Docket Item # 9
BAR CASE # 2006-0243

BAR Meeting
November 15, 2006

ISSUE: Rear addition
APPLICANT: Jessica Bernanke
LOCATION: 707 Chetworth Place
ZONE: RB/Residential

Figure 1- north elevation

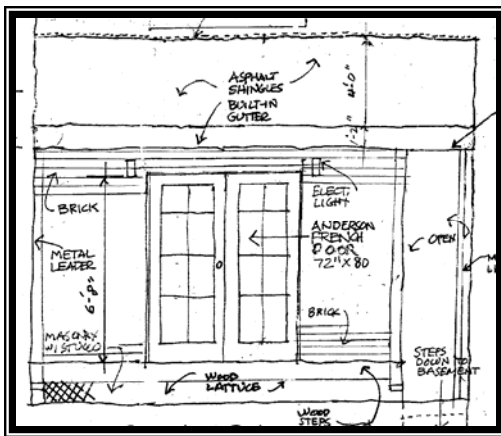
The applicant is requesting approval of a Certificate of Appropriateness for a rear addition to the residential rowhouse at 707 Chetworth Place. The addition is very simple in design and will be one story in height, 10' in length and approximately 13' in width [The dimensions set forth in the drawing are incorrect. Dimensions noted by Staff reflect the variance for the addition as approved by the Board of Zoning Appeals]. The proposed addition is proposed to be clad in brick with a sloped roof which will be covered with asphalt shingles. On the rear (north) elevation there is proposed to be a pair of multi-light French wood doors. A pair of multi-light casement windows are proposed on the west side and no fenestration is proposed on the east side.
